**Subject:** Aux-Drive Gear Bearing Change / 13-Speed MHP Models

**Document Number:** TAIB0867 EN-US

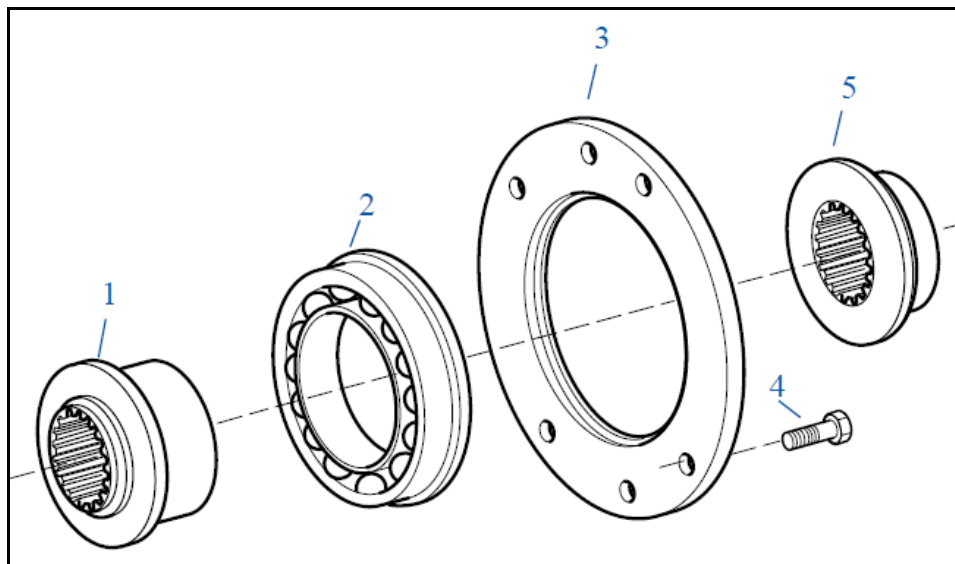
**Issue Description:** 13-speed MHP models built after 3/20/17 now use a 5566508-BOX aux-drive gear bearing in place of the 5566510-BOX. Due to the dimensional differences of these two bearings, the following parts were also used to accommodate this change.

The following parts will be needed if an S-3223 (4309216) service case is used on a transmission originally built with an S-3224 (4308734) case.

- Bearing spacer – 4306314 (item 1)
- Bearing – 5566510-BOX (item 2)
- Retainer – 4304497 (item 3)
- Drive gear spacer – 4304500 (item 5)
- Cooler port adapter kit – K-4292
